2CAN010304

SUBJECT: Arkansas Nuclear One, Unit 2
Docket No. 50-368
License Amendment Request to Change the Spent Fuel Pool (SFP)
Loading Restrictions

Analysis of Proposed Technical Specification Change

**ANO-2 Spent Fuel Pool Arrangement
Figure 3.9.1**

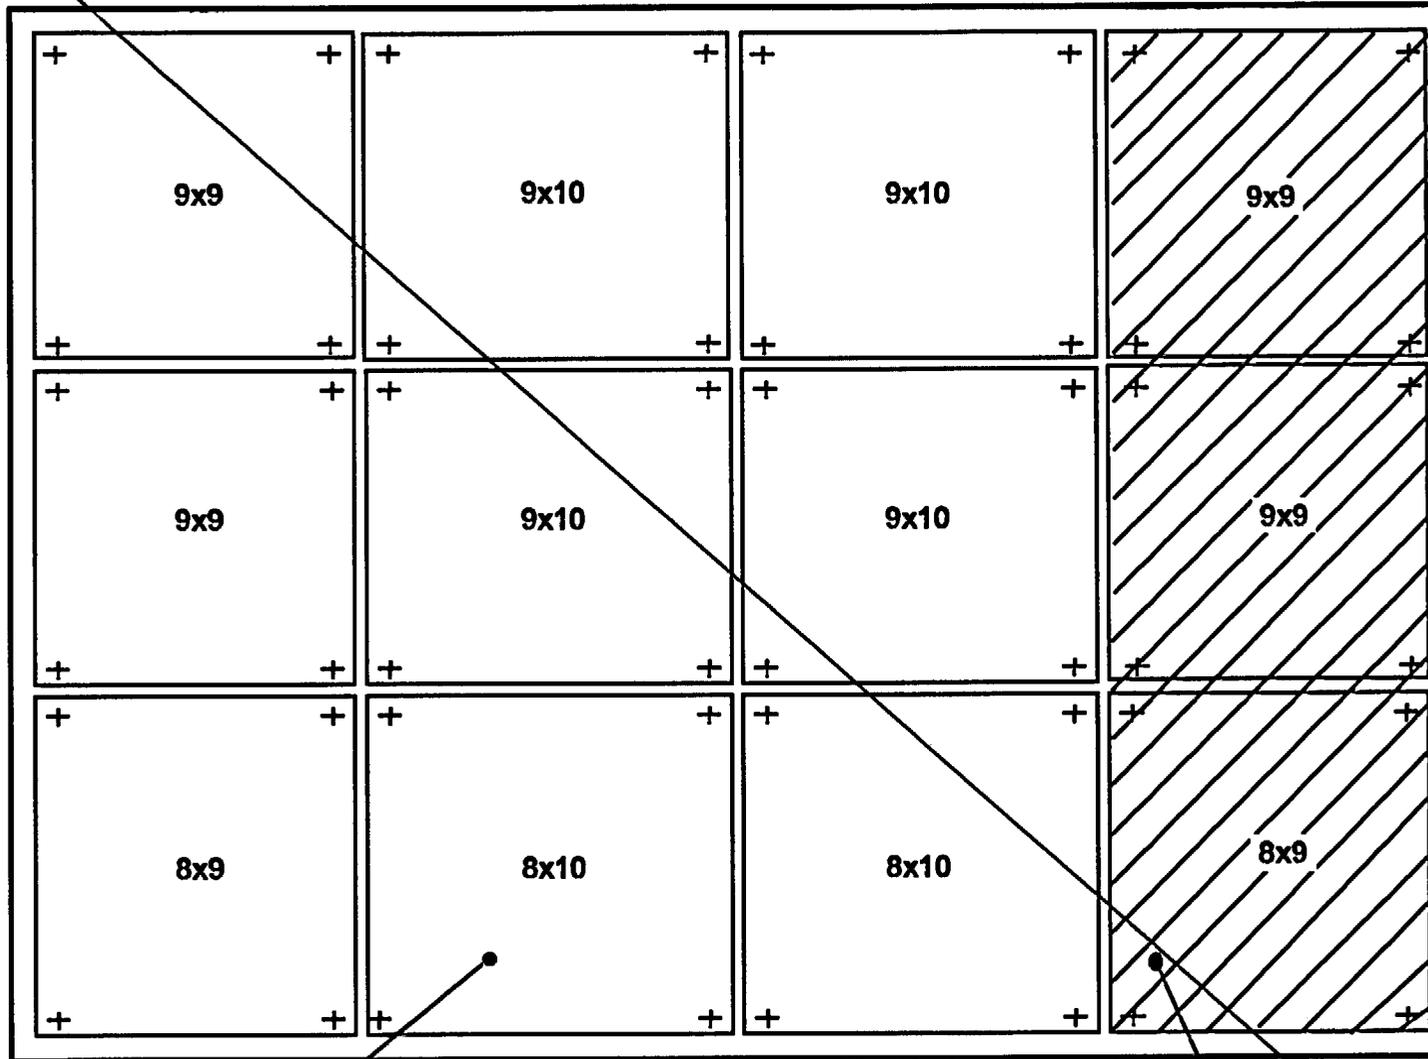
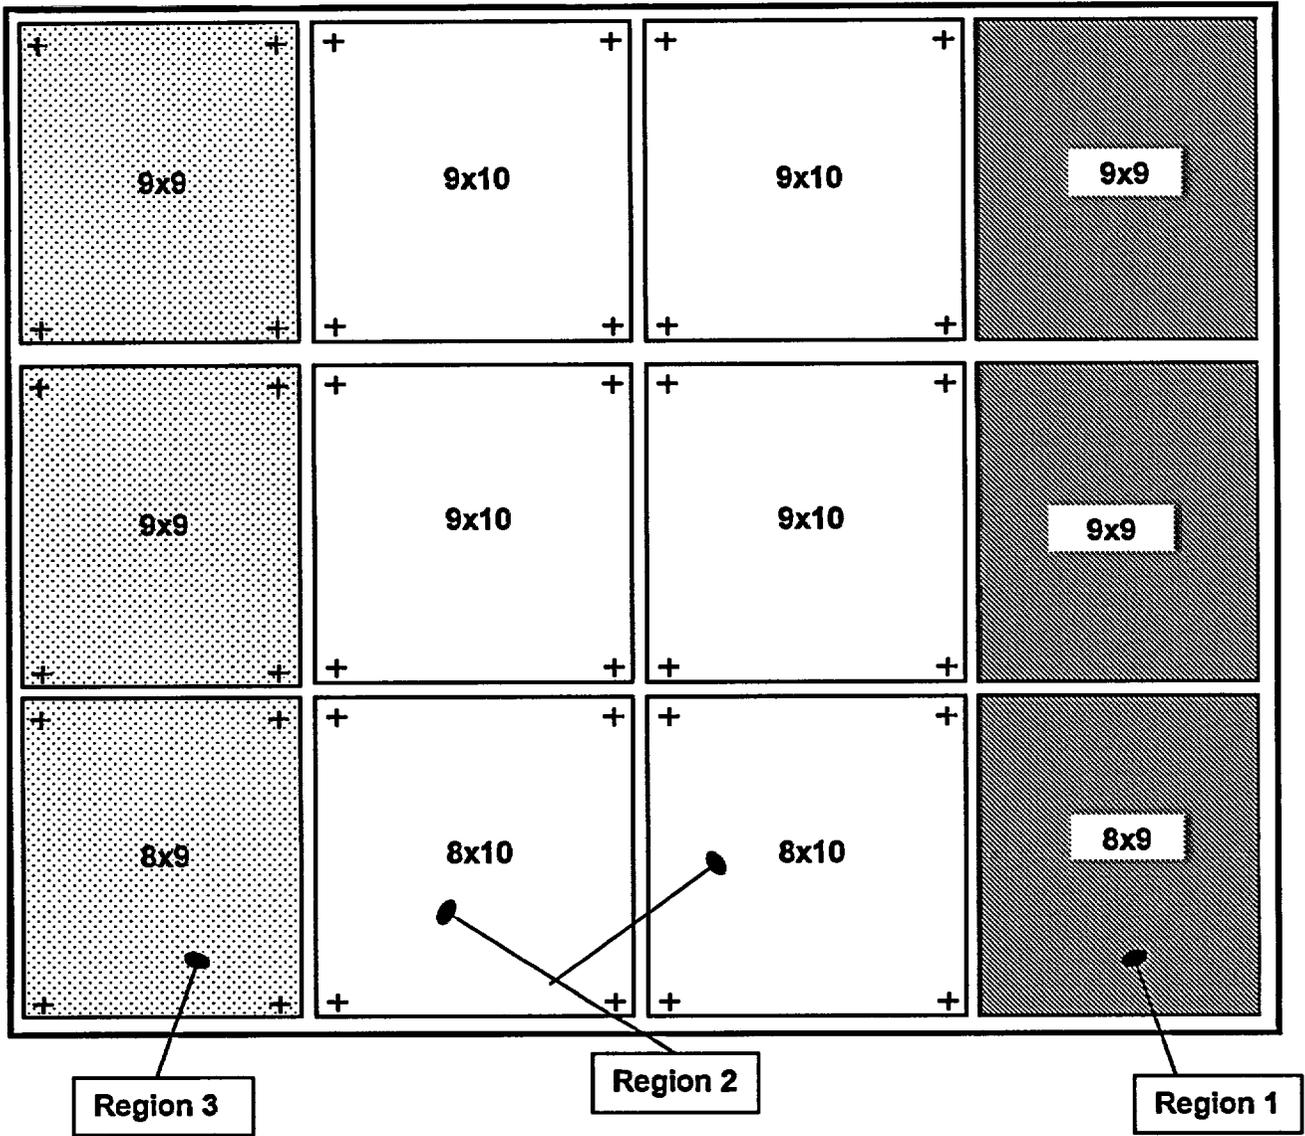
- 3.9.12.b Storage in Region 1 or Region 2 (as shown on Figure 3.9.1) of the spent fuel pool shall be further restricted by the limits specified in Figures 3.9.2 and 3.9.3. ~~In the event a cross-hatch storage configuration is deemed necessary for a portion of either Region 1 or Region 2, vacant spaces diagonal to the four corners of any fuel assembly or vacant spaces on two opposite faces of any fuel assembly shall be physically blocked before any such fuel assembly may be placed in that region (Note 1). Also, the Region 1 storage cells adjacent to the Region 2 interface are restricted to fuel assemblies that are outside of the area of the graph enclosed by Curve A on Figure 3.9.2. In the event a checkerboard storage configuration is deemed necessary for a portion of Region 2, vacant spaces adjacent to the four faces of any fuel assembly shall be physically blocked before any such fuel assembly may be placed in Region 2.~~ The provisions of Specification 3.0.3 are not applicable.

Figure 3.9.2
Bumup versus Initial Assembly Average U-235 Enrichment
Region 1

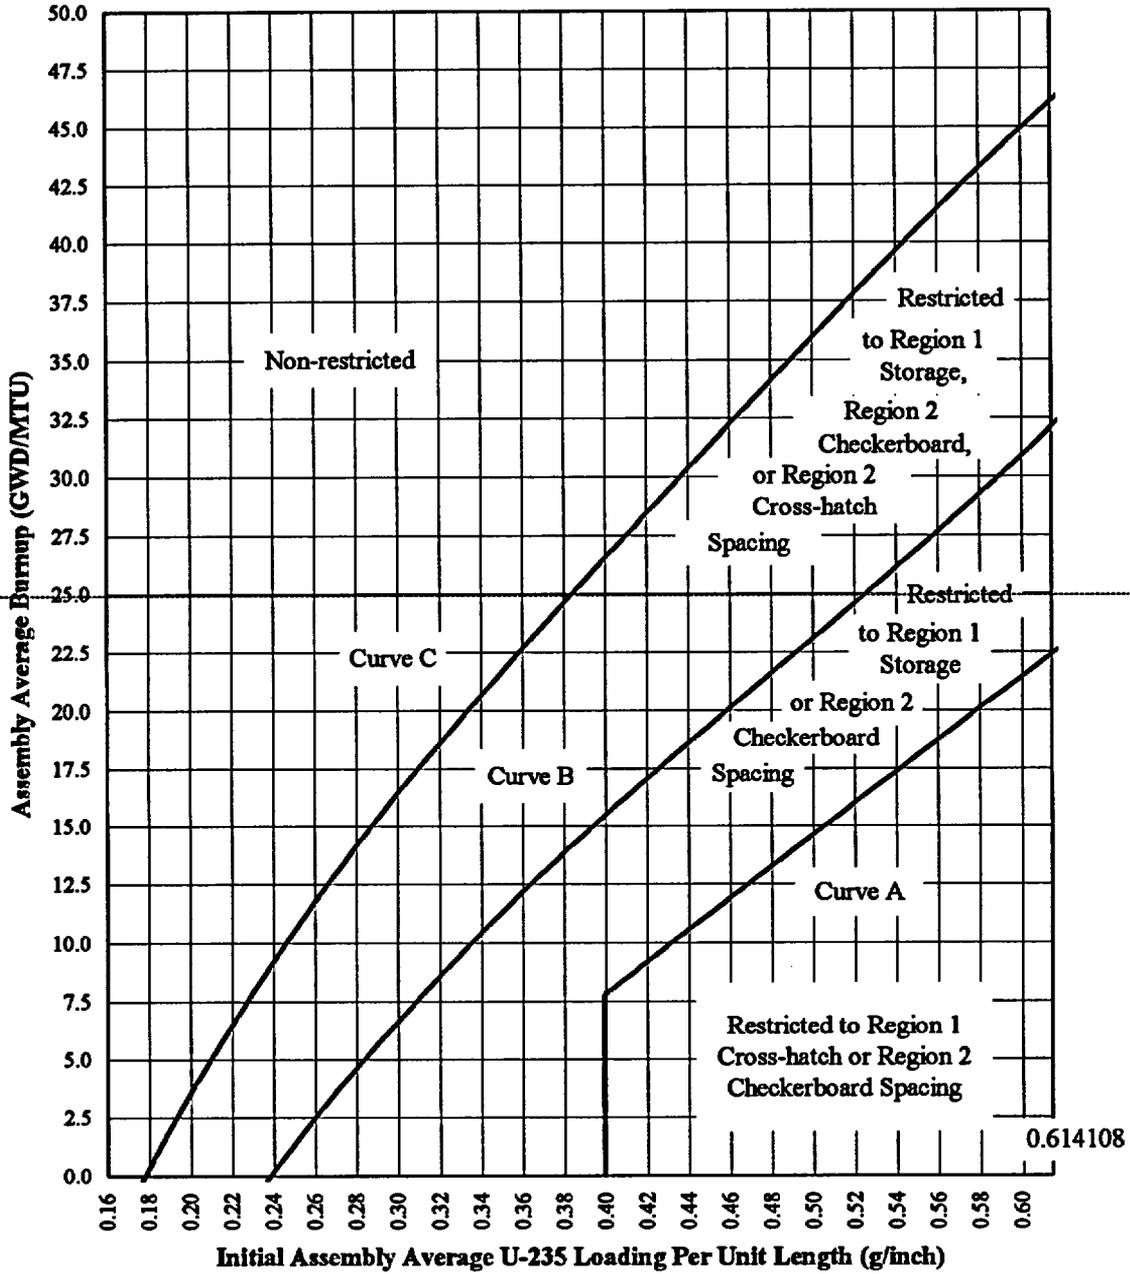
To best reflect the loading restrictions in the two regions, a new figure will be added for Region 2 while the current Figure 3.9.2 will reflect the loading restrictions for Region 1.

Boraflex® in Region 1 and will include new loading restrictions for Region 1. Based on the new criticality analysis, new restrictions will also be imposed on Region 2. This will result in changes to TS 3.9.12.b and Figure 3.9.2. The new Figure 3.9.2 will depict loading restrictions for Region 1 and a new Figure 3.9.3 will be added for the loading restrictions in Region 2 such that loading restrictions for Region 1 and Region 2 are reflected on separate figures. In addition, a portion of the current Region 2 SFP racks will be modified by the installation of Metamic® poison panel inserts. This will result in the creation of a new Region 3 which will allow unrestricted storage of new and spent fuel. The creation of the new region will require a change to TS Figure 3.9.1. Entergy has submitted a topical report to allow the use of Metamic® in SFP applications. Approval of the topical report is required to support this submittal.

Note 1 associated with TS 3.9.12.b allows storage of fuel assemblies in the vacant spaces created in the most peripheral row/column of Region 1 as required by Curve A on TS Figure 3.9.2. The new criticality analysis redefines loading restrictions for Region 1; therefore, this note is no longer applicable and will be deleted.

SR 4.9.12.b requires verification that the fuel assemblies that will be placed in the SFP are within the limits of Figure 3.9.2. The proposed change will modify this SR to reflect the addition of a new curve to ensure that the current requirement is maintained.

Curve A = $68.008x - 19.366$ when $x > 0.399184$
 Curve B = $239.01x^3 - 347.75x^2 + 243.18x - 41.452$
 Curve C = $-714.35x^4 + 1335.80x^3 - 946.44x^2 + 394.52x - 47.040$
